Town of Parker Community Development Department
Development Review Division
Attention: Amber Wood-Hicken

Application Type: **Site Plan – Non-Residential**
Status: **First Referral**
Application Name: Douglas 234 F6 AMD 2 L10B – Commercial Bldg
Case/AP#: **SP25-021**
Referral Received: April 7, 2025
Comments Due: May 5, 2025

Review date: **April 25, 2025**
Plan reviewer: **Randall L. Capra, rcapra@parkeronline.org**
Phone: 303.805.3163

TOWN OF PARKER FIRE/LIFE SAFETY:

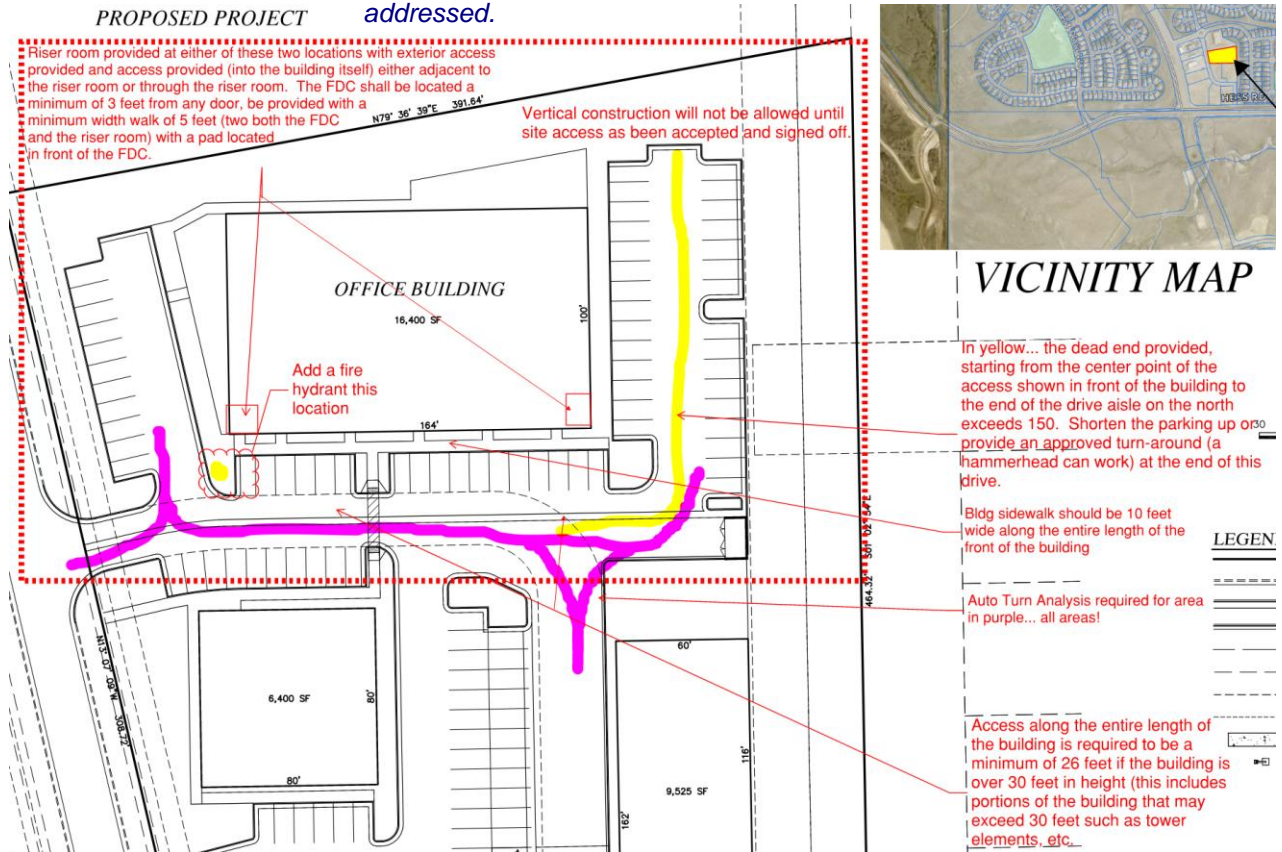
The fire hydrant shall be provided within 40 feet of the building (specifically the riser room... with the water room shown on the north side of the building not being acceptable for this project). See the bullet points that must be addressed for the riser room and the utility drawings noted in item #5 below.

This issue was addressed on November 20, 2024. This document identified the location of two riser room locations that were deemed to be acceptable. The document also required that the applicant provide an auto turn analysis and fire hydrant. See a copy of the redlined document below. Note – the fire hydrant will be required to be located in the center island on the south side of the building now that a more complete site plan has been provided. See a snapshot of this document below (the constraints of the site are more obvious with the current submittal):

All of these comments have been addressed.

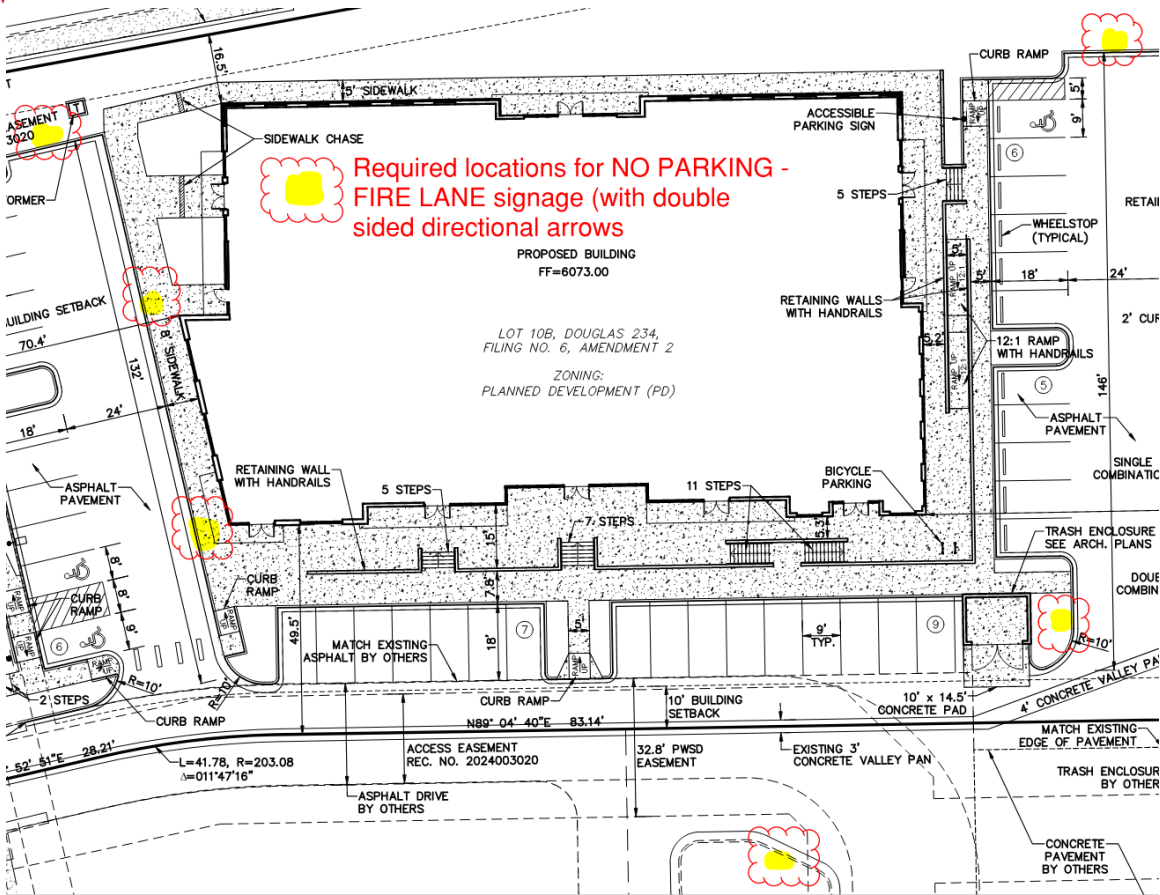
8. The Town of Parker requires that fire apparatus access roads meet the clear-width and weight-bearing standards of the jurisdiction in which the project is located. Roadways shall be designed to support the imposed weight of fire apparatus, 30-ton, two axle and 40-ton three, axle vehicles. *An unimpeded clear width of 26-feet shall be maintained at all times (26-feet for buildings that exceed 30-feet in height).* The applicant has met the required 26-foot access road on all four sides of the accessible portion of the building though the applicant has not provided the required auto-turn analysis required for all projects. This analysis shall be performed for all portions of the site including the 24-foot drive aisle provided on the s/w side of the front of the building.

The building height is now less than 30' tall.

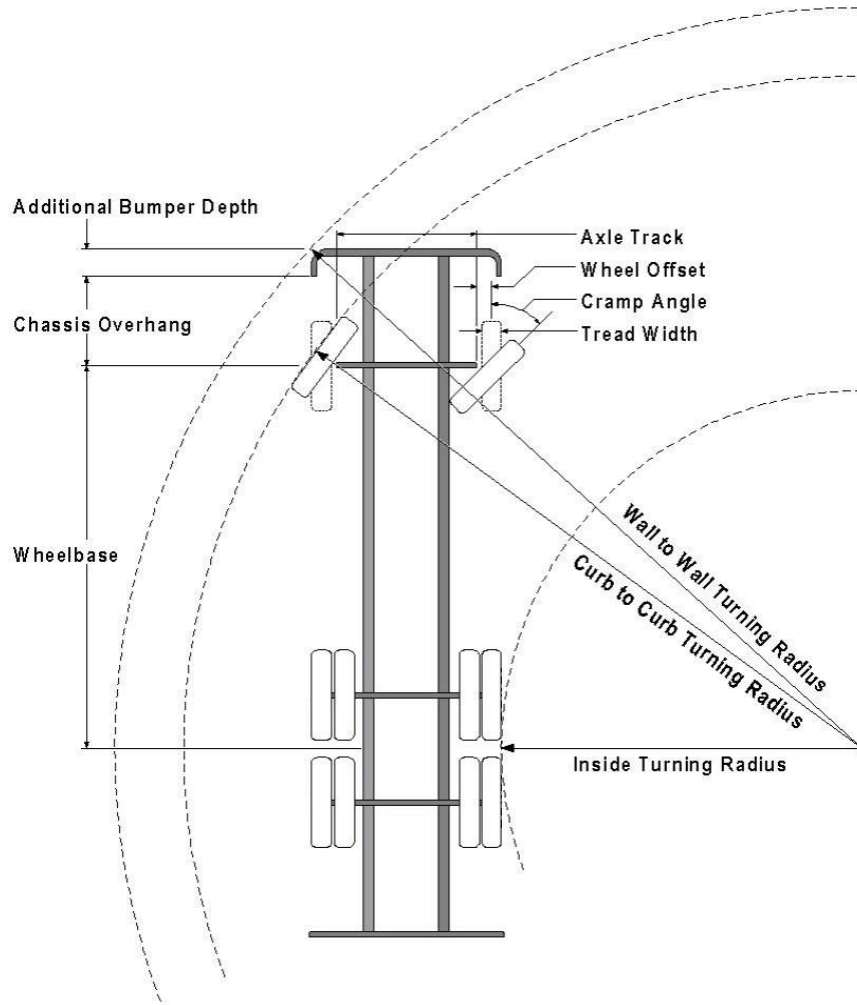
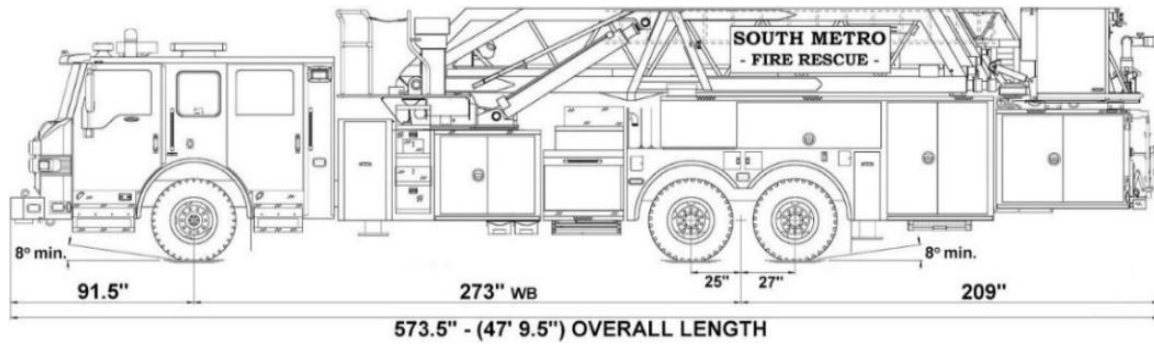
9. The applicant has not provided a signage plan; the signage plan shall address all signage including the requirement for NO PARKING – Fire Lane Signage. See the redlines below for location of required NO PARKING – FIRE LANE (with double sided directional arrows) signage in the location shown below;

Note - The Town of Parker requires that fire apparatus access roads meet the clear-width and weight-bearing standards of the jurisdiction in which the project is located. Roadways shall be designed to support the imposed weight of fire apparatus, 30-ton, two axle and 40-ton, three axle vehicles. **An unimpeded clear width of 26-feet shall be maintained at all times.** As such, any location where parked vehicles would obstruct this clear width requirement will require “NO PARKING – FIRE LANE” signage. *This signage shall be red on white. Update design criteria has been provided at the end of this document; ensure compliance when resubmitting.*

Fire lane signage is now shown.
